FINAL
ENVIRONMENTAL IMPACT REPORT

METROPOLITAN
TRANSPORTATION AUTHORITY
WEST LOS ANGELES
TRANSPORTATION FACILITY
AND
SUNSET AVENUE PROJECT
VENICE

(ENV 2004-1407-EIR)
(SCH No. 2003121036)
(SCH No. 2004031139)

FEBRUARY 2005

Figure II-2
 West Los Angeles Transportation Facility
 Site Plan

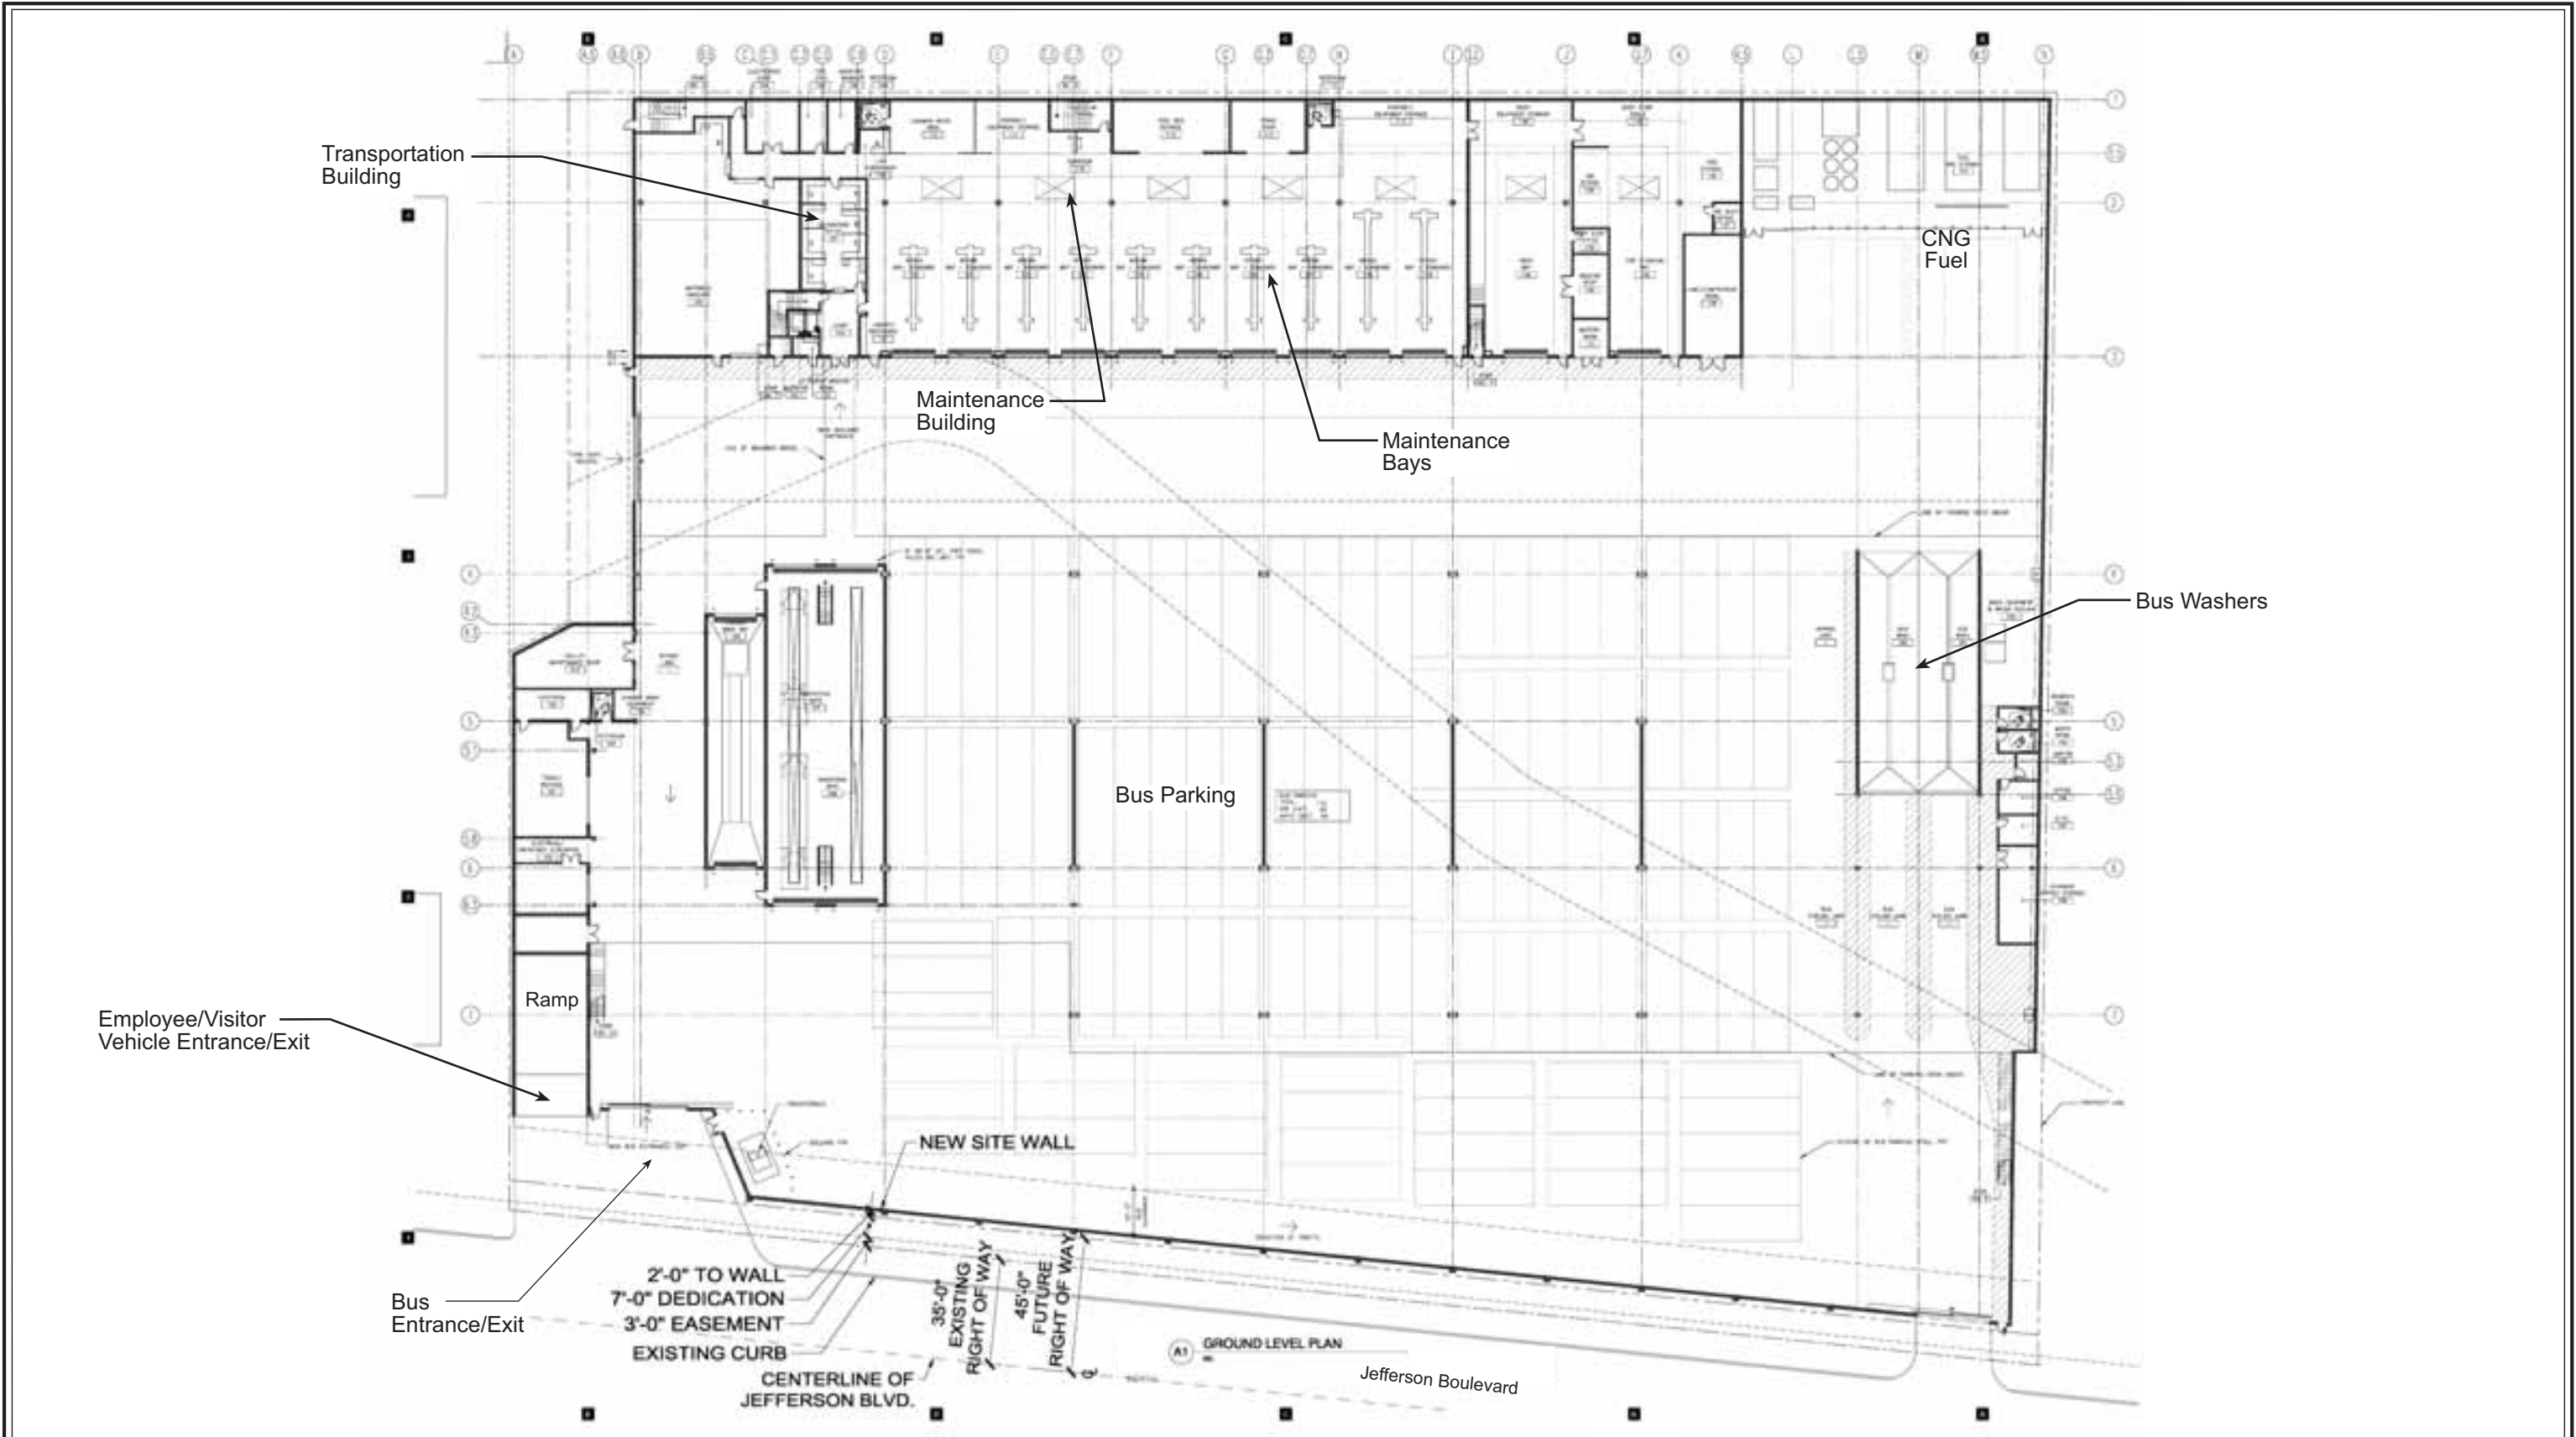
II.(1) Volume I, Section II, Project Description, Figure II-2, on page 69, has been enhanced to show minor modifications and additional information.
